MIL-R-71135 (AR)
 AMENDMENT 2
14 September 1994
 SUPERSEDING
 AMENDMENT 1
 8 December 1992

MILITARY SPECIFICATION

RIFLE, 5.56MM: M16A2E3

FIGURE I. Targeting and accuracy diagram.

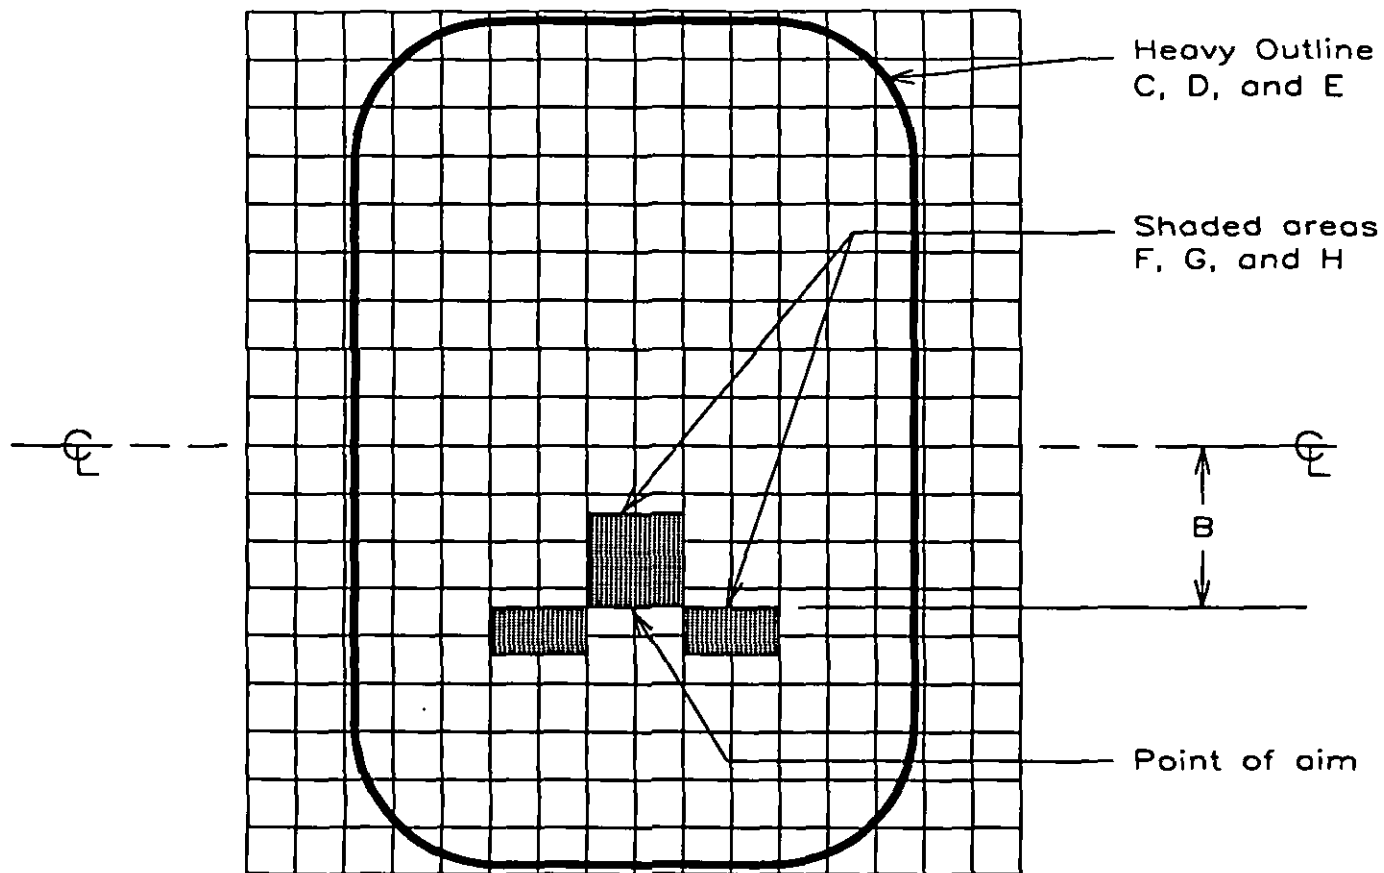
Figure I: Delete in its entirety and substitute the following:

- A - 10 shot group extreme spread
- B - Vertical distance from target centerline to point of aim
- C - Height of heavy outline
- D - Width of heavy line
- E - Radius of corners of heavy outline
- F - Width of shaded areas
- G - Height of upper shaded area
- H - Heights of lower shaded areas
- I - Grid dimensions

Target Diagram For		Dimensions in inches								
		Group	P.O.A.	Heavy Outline			Shaded Areas			Grid
Meters	Yards	A	B	C	D	E	F	G	H	I
91.4	100	5.0	3.5	17.6	11.6	2.8	2.0	2.0	1.0	1.0
